ROSA Inc.
Ramapo Organized for Sustainability and a Safe Aquifer
PO Box 712
Pomona, NY 10970

RE: Comments regarding Patrick Farm NYS DEC Application

Exhibit A

Fill Northwest of Pond for buildings 127 + 88 on extremely steep slope

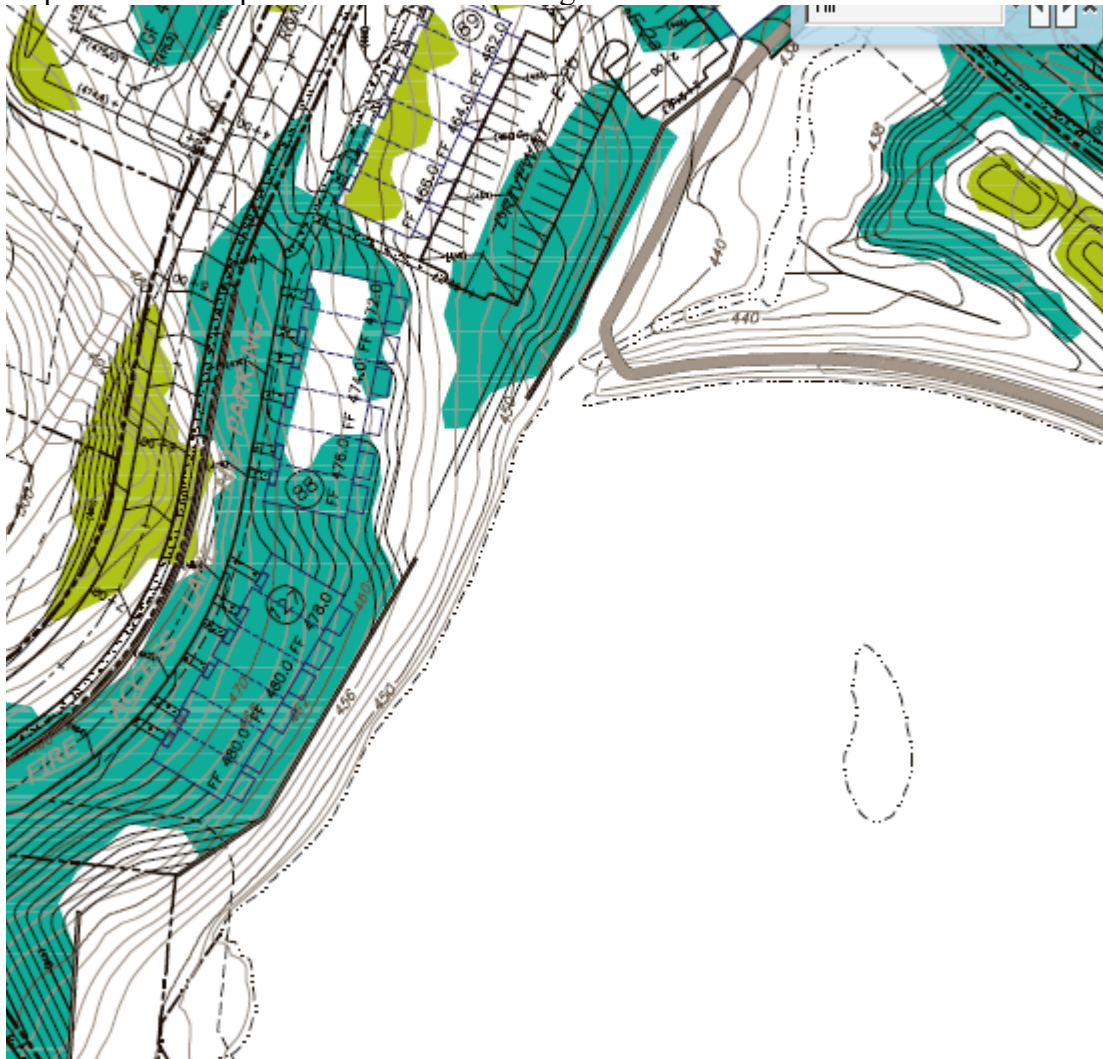
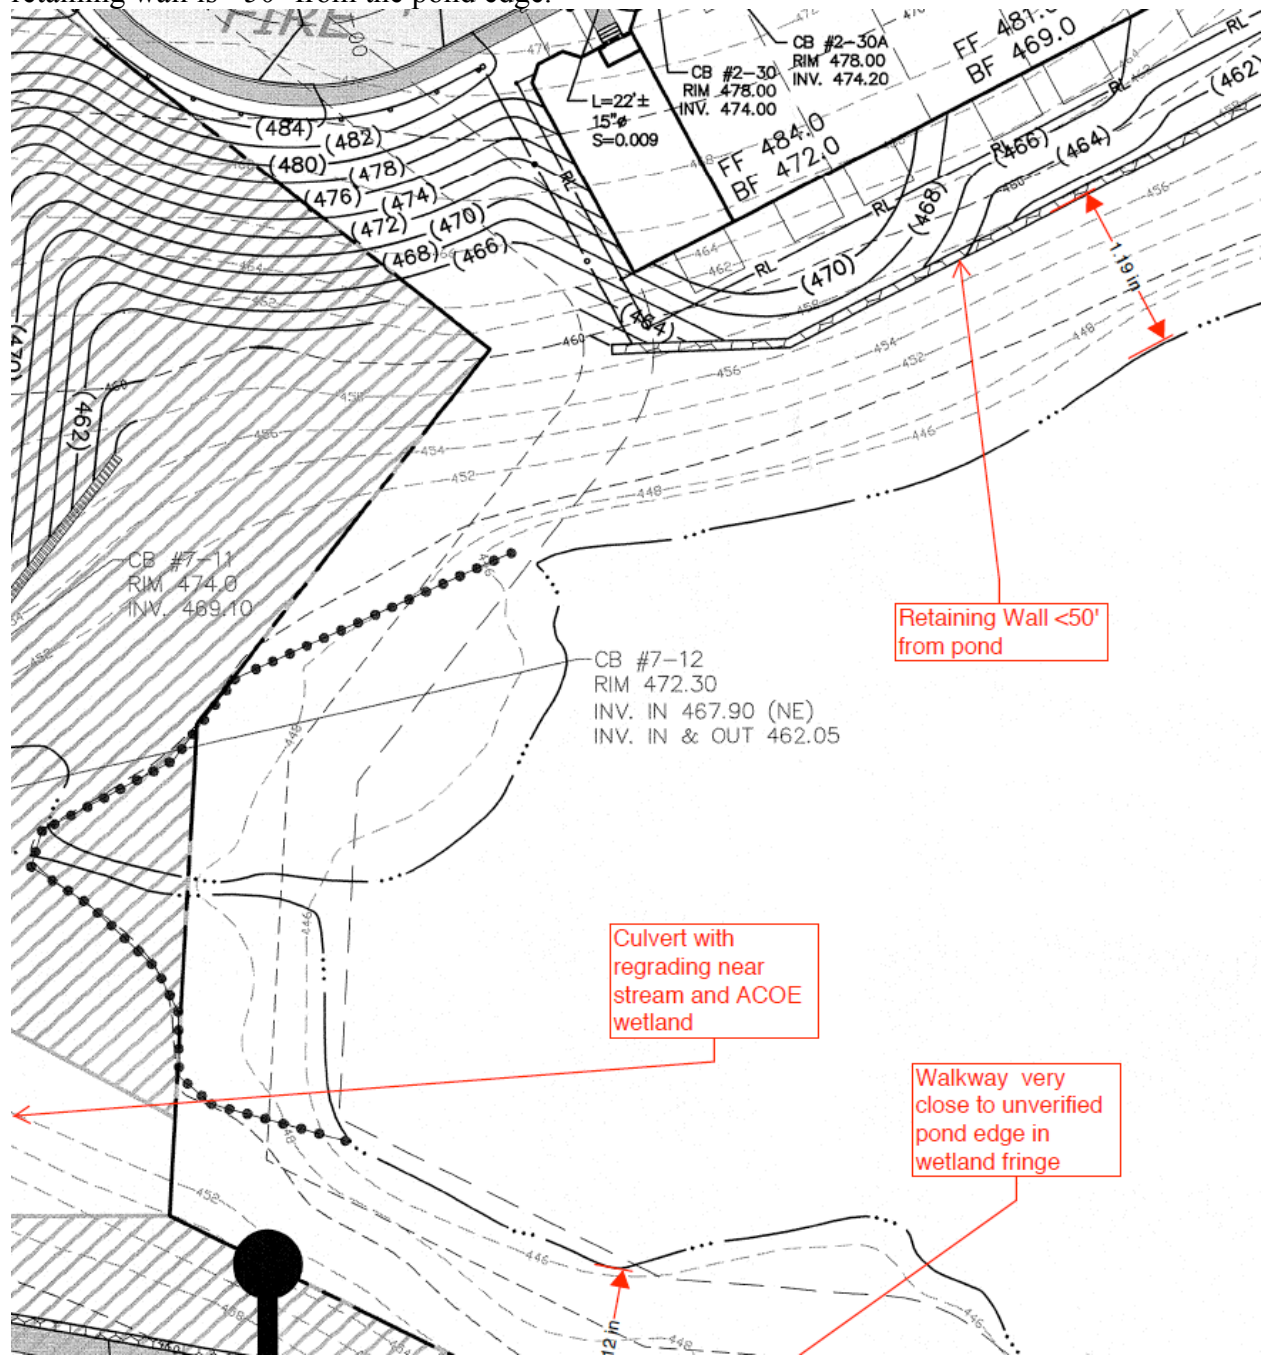
The following excerpt from the cut and fill Figure 3.1-7 of the DEIS shows plans to fill the steep slope north of the pond and build a retaining wall.

The following is from Figure 7 of the Final Site Plan for the Condominiums and shows that this retaining wall is <50' from the pond edge.

Culvert #1 - Road B Stream Crossing North of Pond Dam

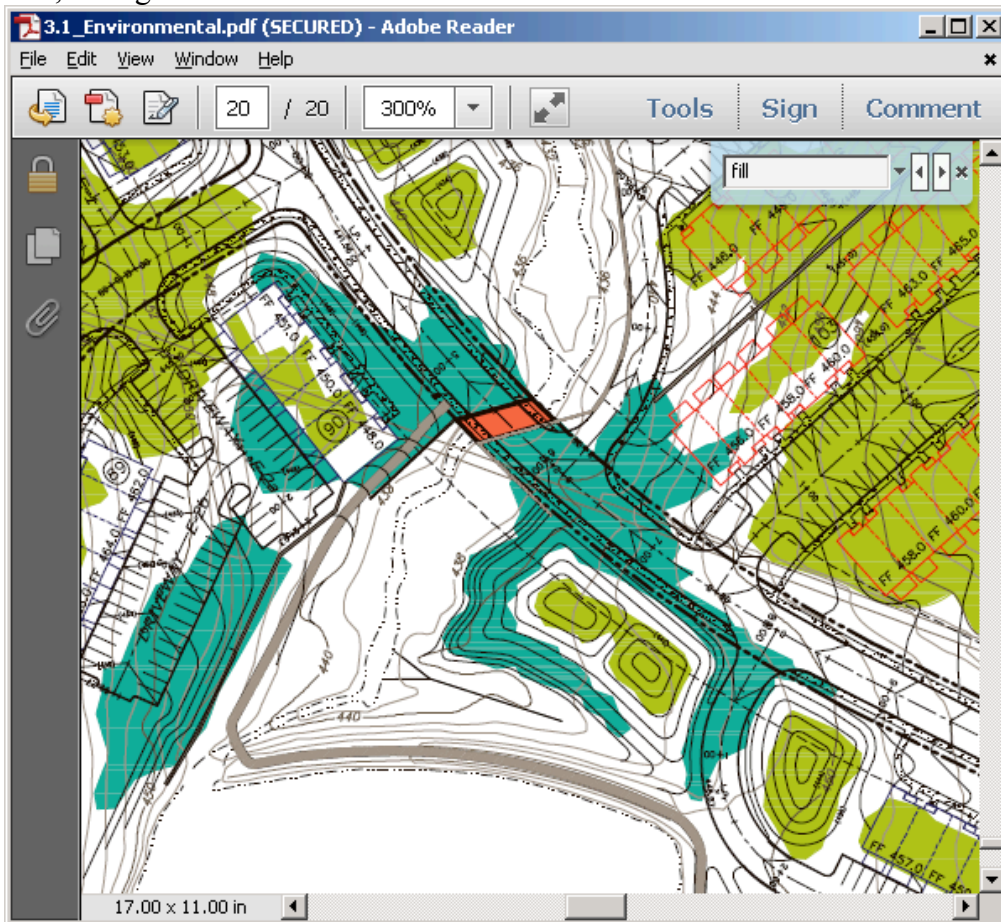
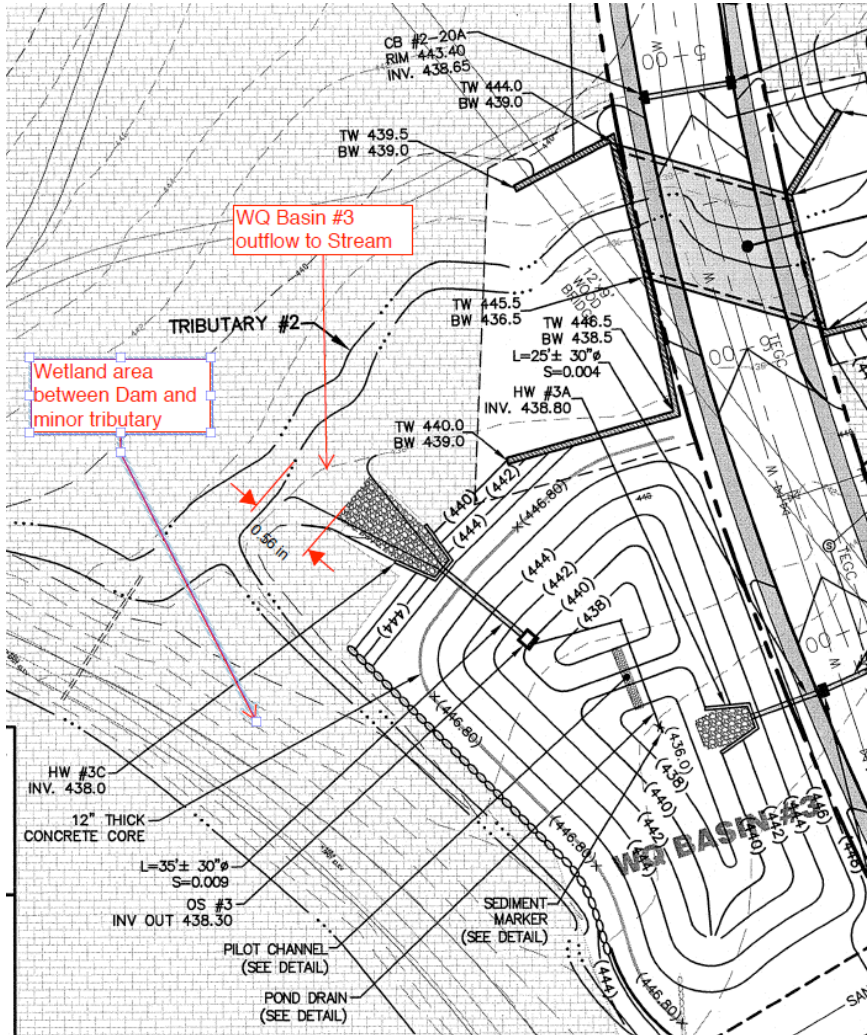
Current application does not show cut and fill plans but show that this culvert is still planned in the same location. Area on north side of dam has wetland properties and should be evaluated prior to approval.

The following screen shot shows a planned stream cross across Class B Stream from Pond. It was taken from section 3.1 of the DEIS Figure 3.1-7 Cut and Fill Analysis Map; dark green = fills, lime green = cuts.

Following is an extract from the final Subdivision Plan Drawing #14 showing that this culvert is still planned for the project.

Along Stream North of Pond

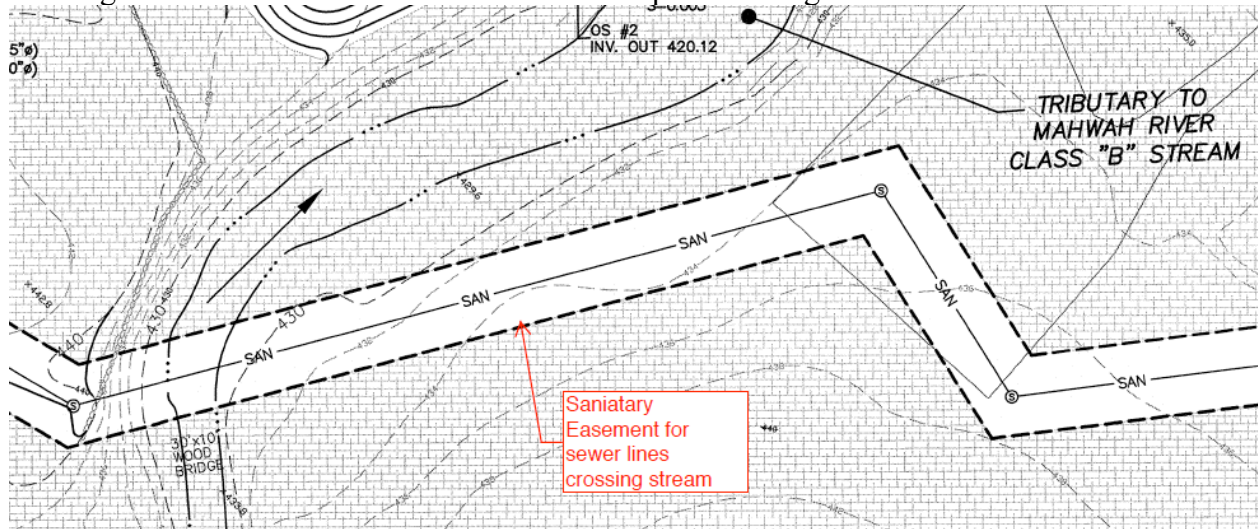
North of the pond dam but south of Location B there is a sewer line crossing the stream near building #54. This is taken from final subdivision plan drawing #14

Immediately north of dam is a minor tributary to the class B stream and this flat area is a potential wetland area. Water Quality Basin #3 is located here with an outflow located ~25' from the main stream. (See above section on WQ Basin #3)

Dam Area Details from Drawing 7 of Condominium Site Plan – Grading and Drainage 1 of 5

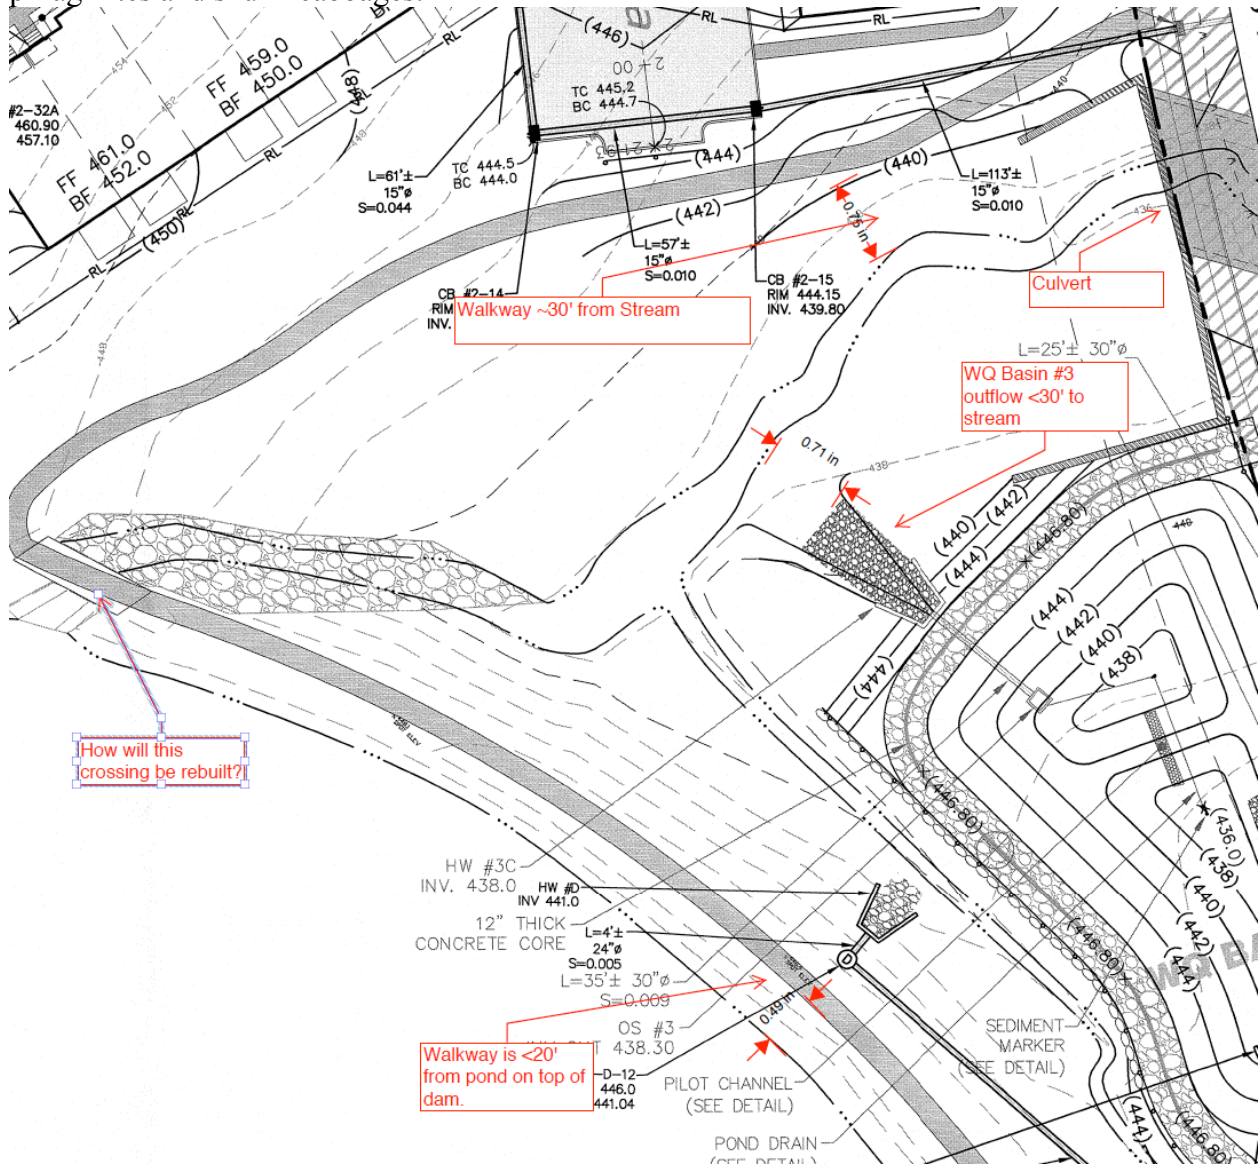
DEC should ask for plans that include 50' boundaries to evaluate the walkway being planned approximately 30' from the stream and <20' from the stream edge, the culvert over the stream, and the drainage from WQ Basin #3. All of this is in an area where there are patches of phragmites and skunk cabbages.

North of Dam Area with Details from Drawing #9 – Grading and Drainage 1 of 5

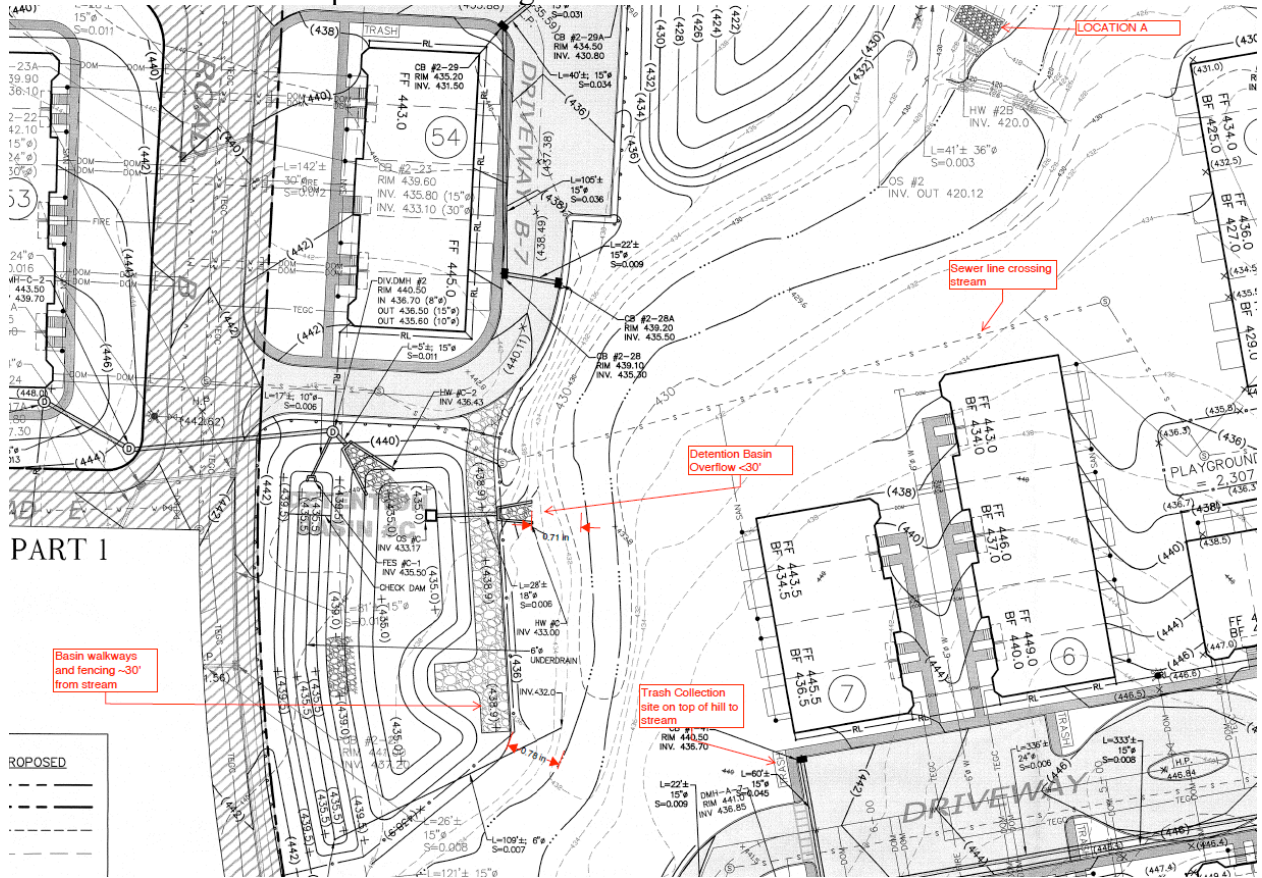
The details below show basin and walkways <30' from stream, sewer line crossing stream and trash collection area at top of hill leading down to stream.

Drawing #8

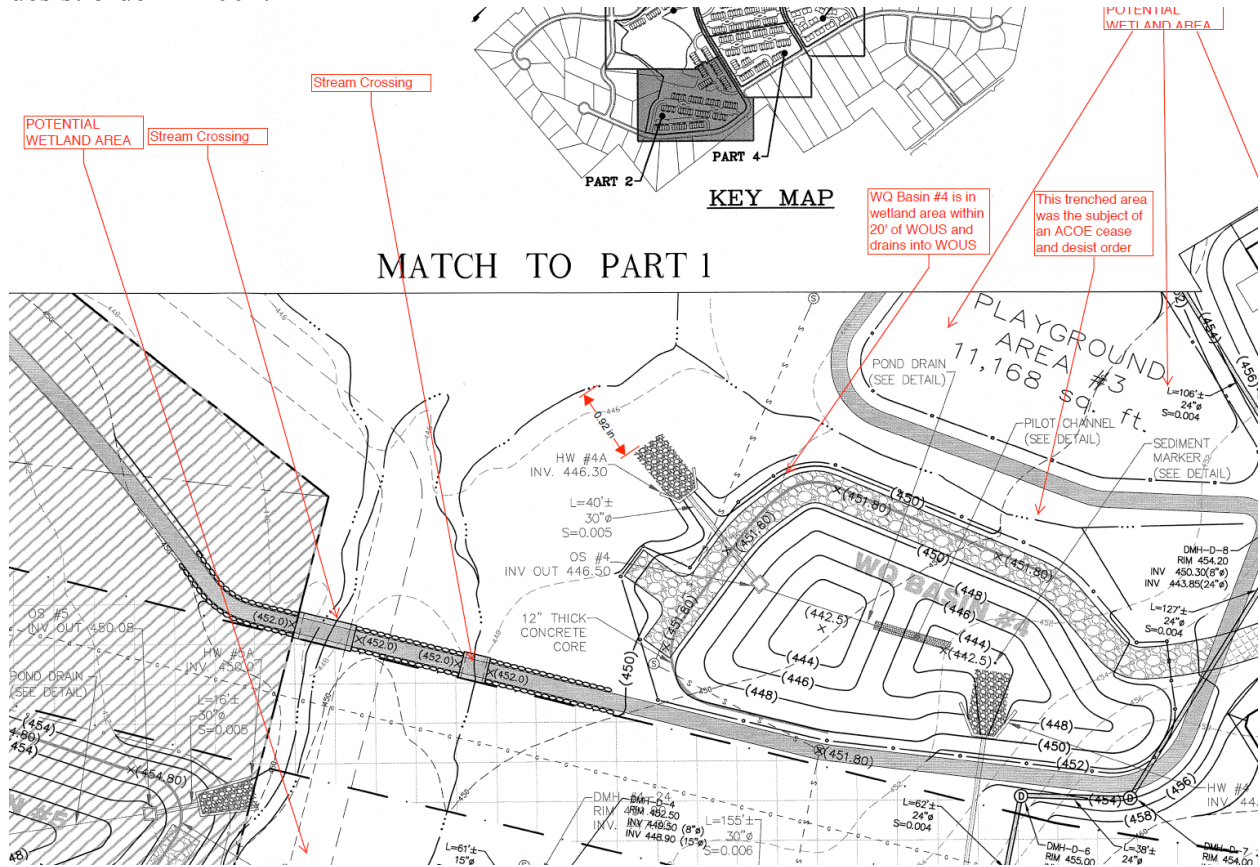
The following shows the detail of the planned development for the area to the south/southeast of the pond where two tributaries converge into the pond in a wetland area. WQ Basin #4 outflows <40' from the pond edge as drawn and is being built adjacent to area subject to ACOE cease and desist order in 2004.
